Subdivision and Land Development Cover
Page for SLD # 04-23

Project Name: The Miquon School

Name of Subdivision/Land Development: The Miquon School — Heart of Campus Improvements

RE: Sketch Plan Review
2025 Harts Lane - Miquon School
Whitemarsh Township, Montgomery County, PA
S/LD # 04-23
Our Project Number 2023-03088

Drawing Number: **C10.1**

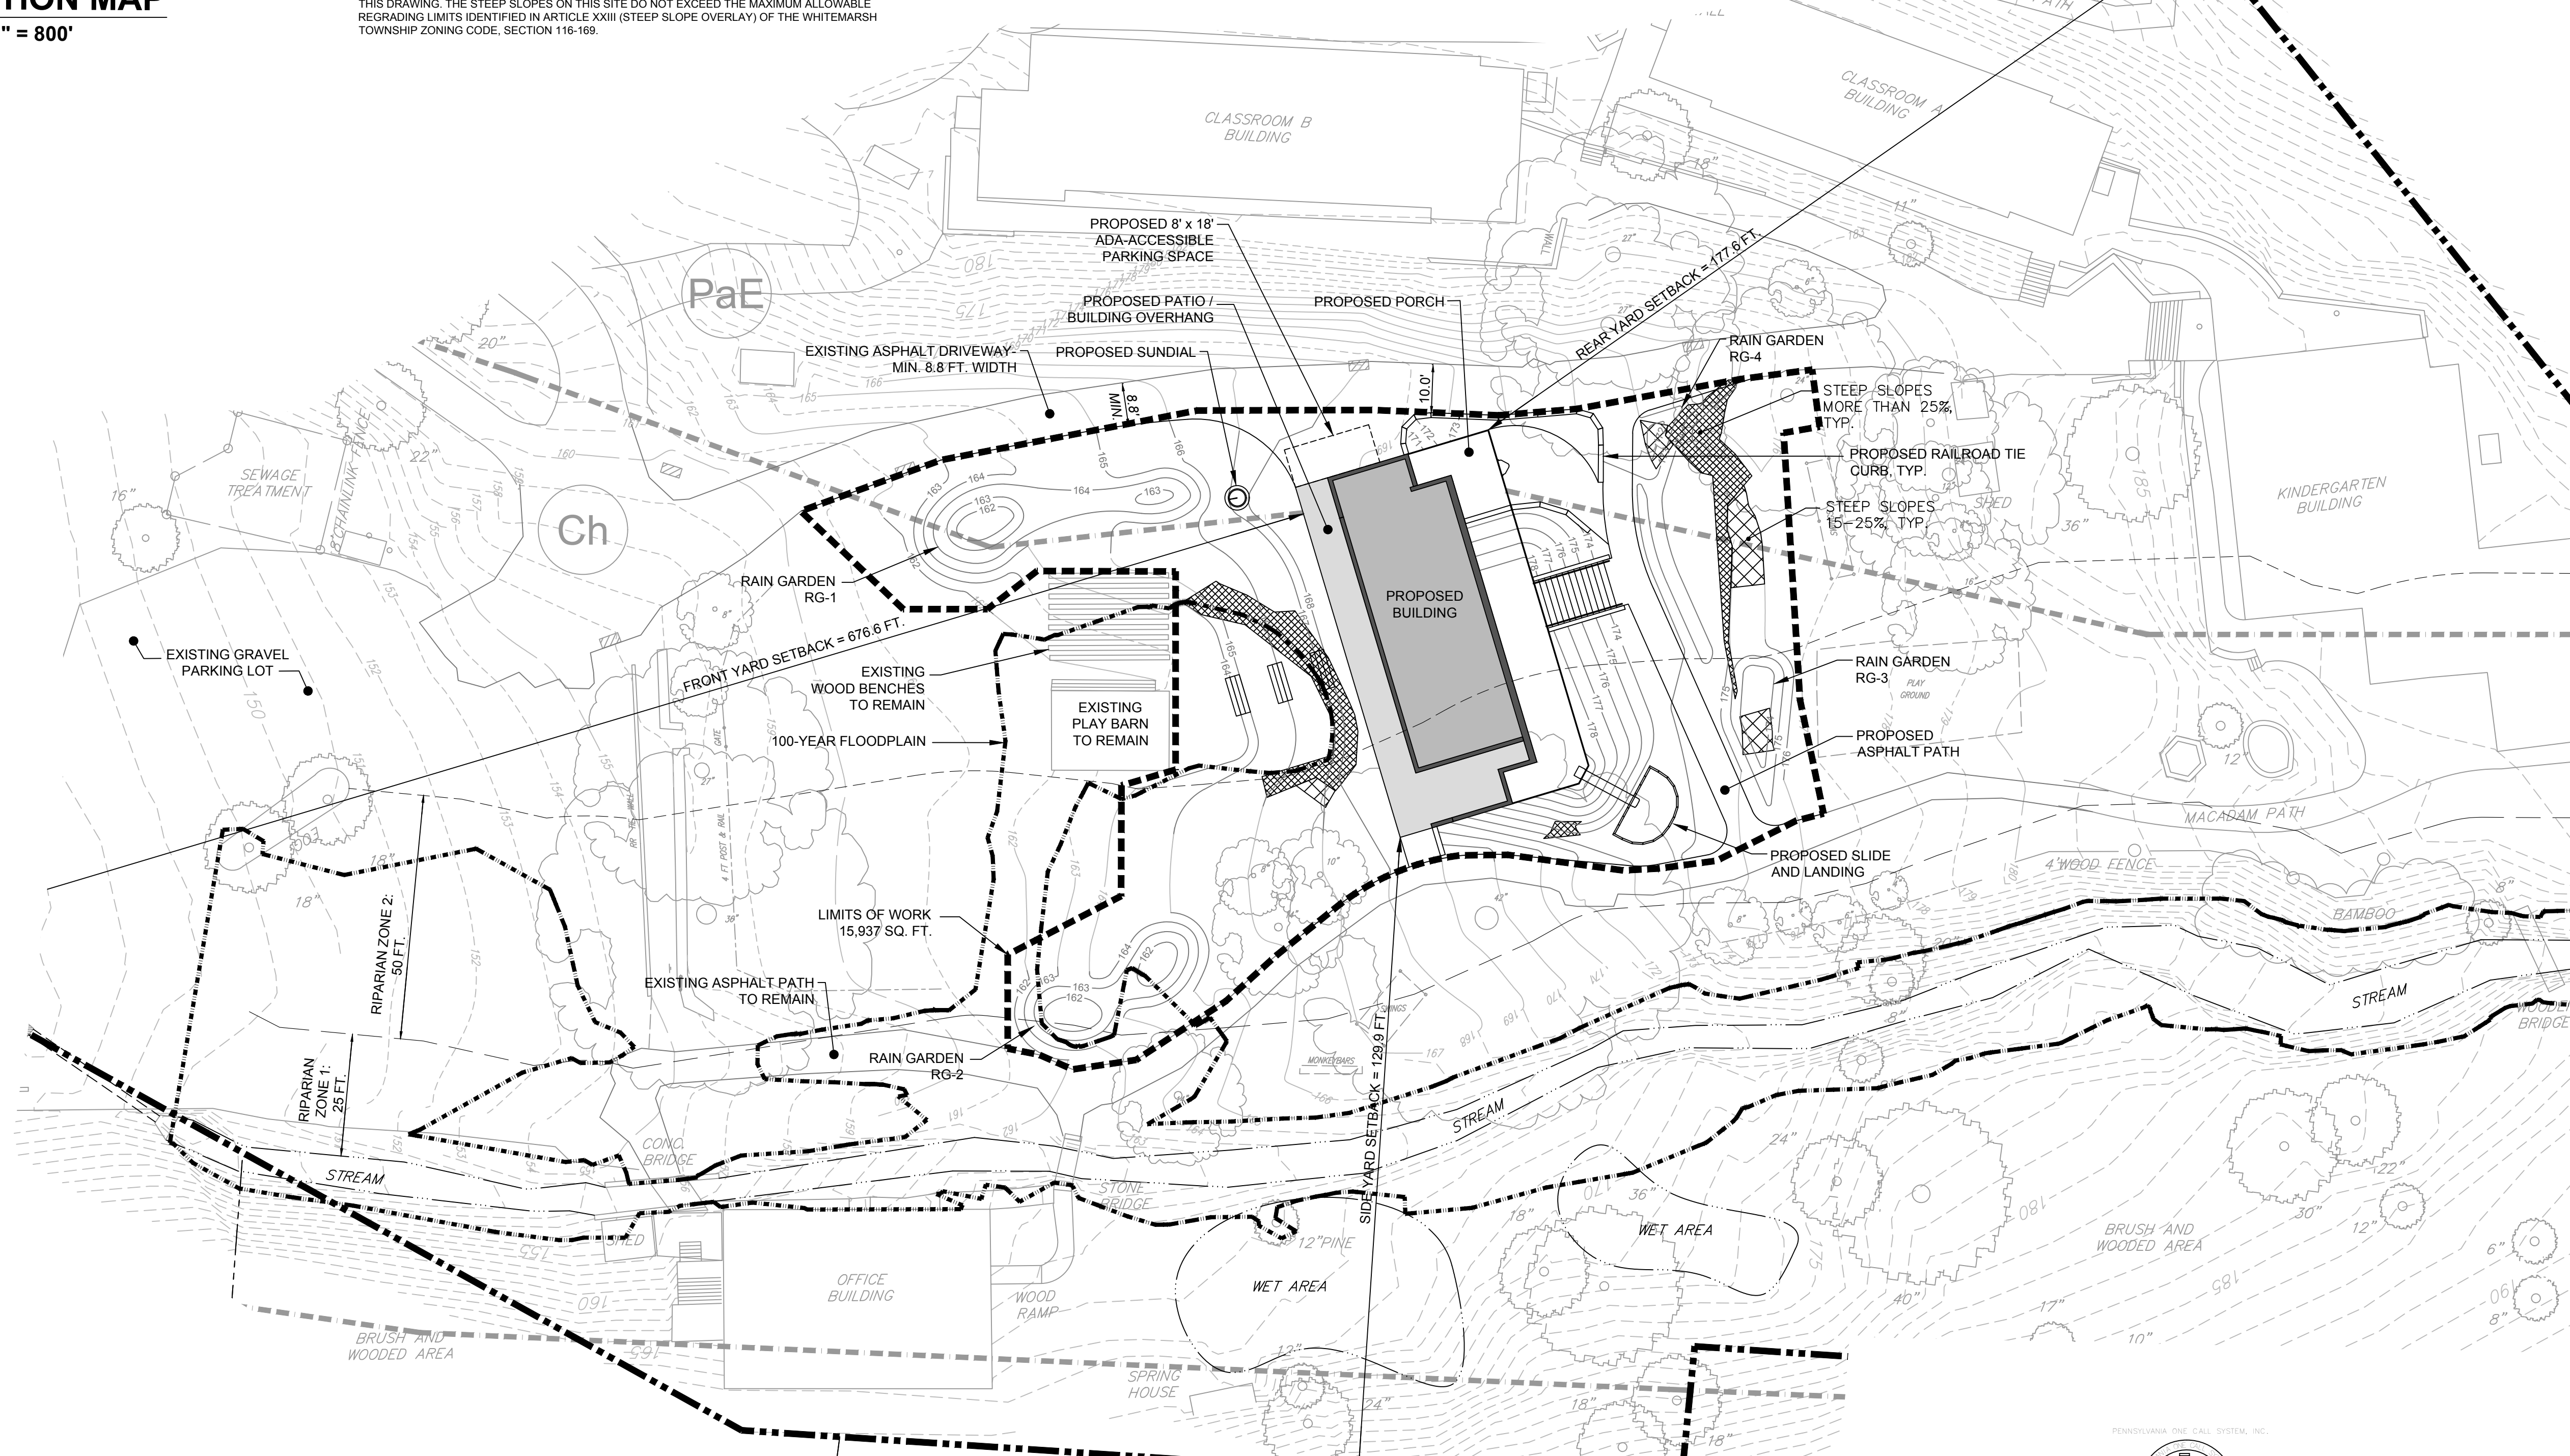
- Also with respect to required parking for the new building, Note #16 on the site plans indicates that no additional parking is required because a building is being removed and the number of faculty and classrooms is the same. However, the plans do not show the location of the building being removed, nor do they list the number of classrooms or faculty. It should also be noted that the parking requirement also factors in area used for offices.

10. **§116-260.F.** In accordance with this section, any type of permanent structure is prohibited within the Riparian Corridor Conservation Overlay District (except those associated with uses permitted in said district). A portion of the proposed building (including a portion of the porch and patio), the proposed slide and landing, as well as a portion of the proposed asphalt trail, are all located within the Riparian Corridor Conservation Overlay District. Variance to allow these uses here must be sought; the need for such variance is noted in the Zoning Summary Table on the plans.

Drawing Title:
EXISTING STEEP SLOPES SUMMARY

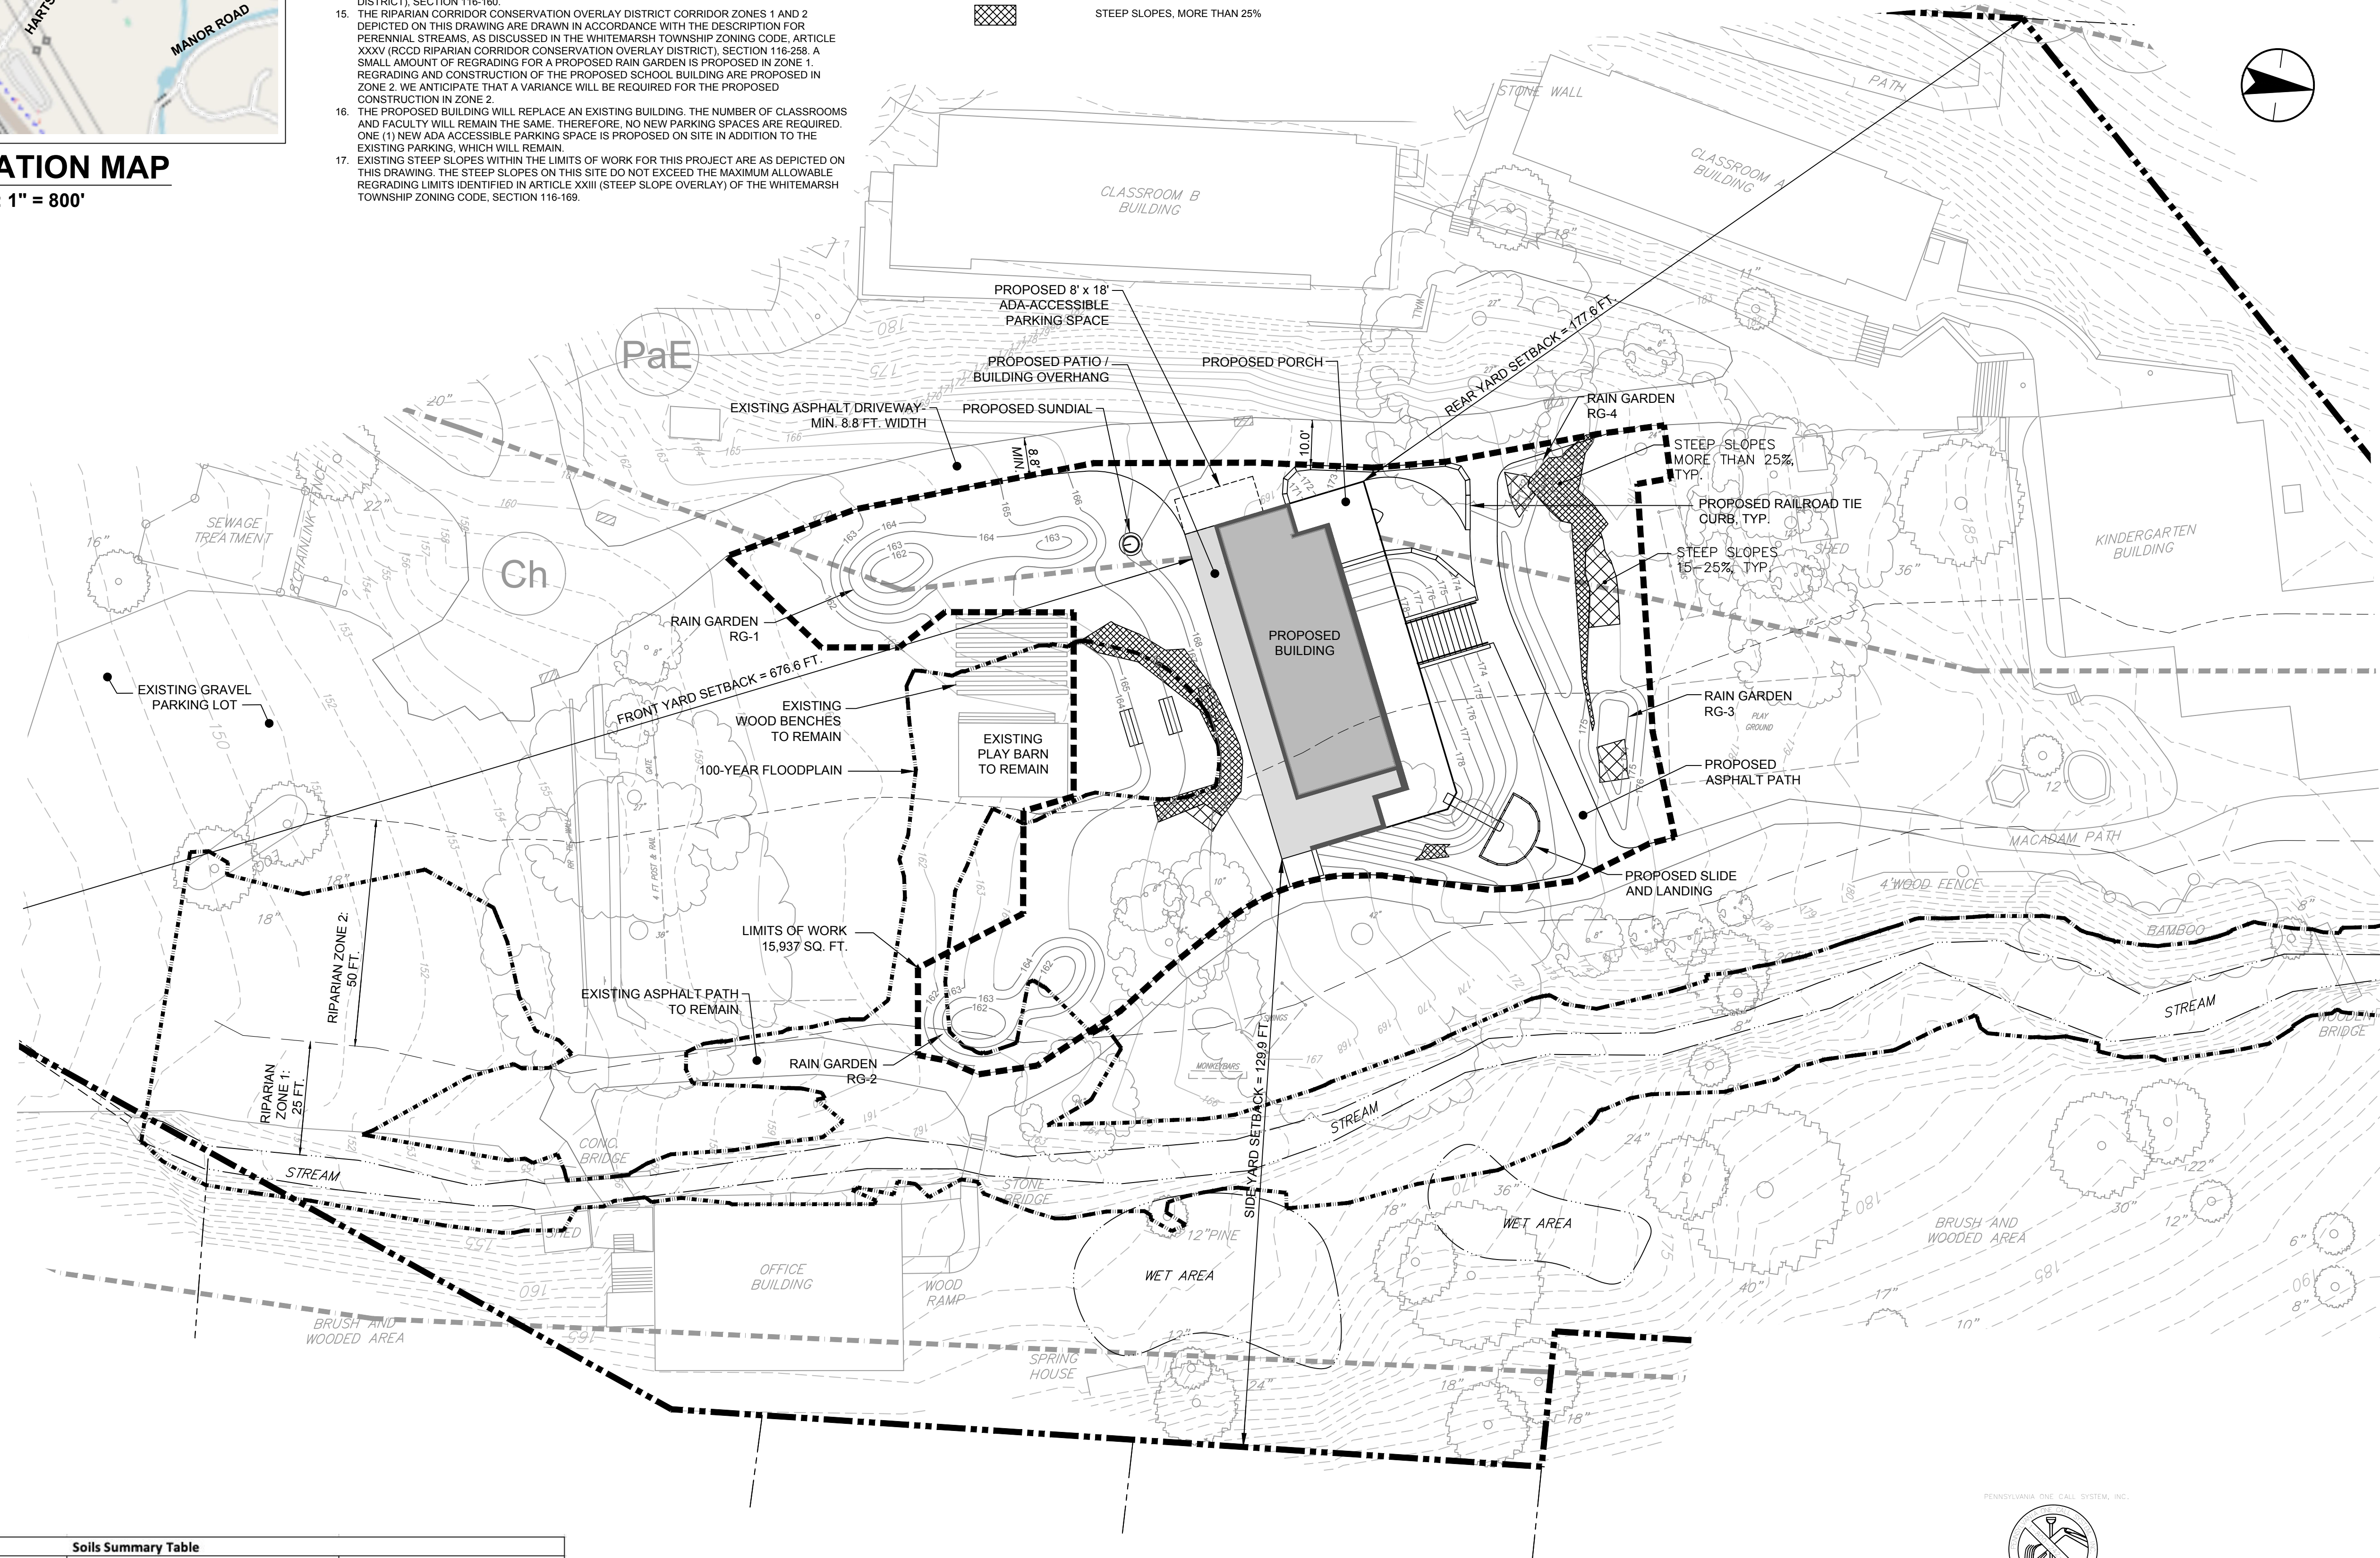
- EXISTING STEEP SLOPES WITHIN THE LIMITS OF WORK FOR THIS PROJECT ARE AS DEPICTED ON DRAWING C10.1, PROJECT SITE PLAN. THE STEEP SLOPES ON THIS SITE DO NOT EXCEED THE MAXIMUM ALLOWABLE REGRADING LIMITS IDENTIFIED IN ARTICLE XXIII (STEEP SLOPE OVERLAY) OF THE WHITEMARSH TOWNSHIP ZONING CODE, SECTION 116-169.
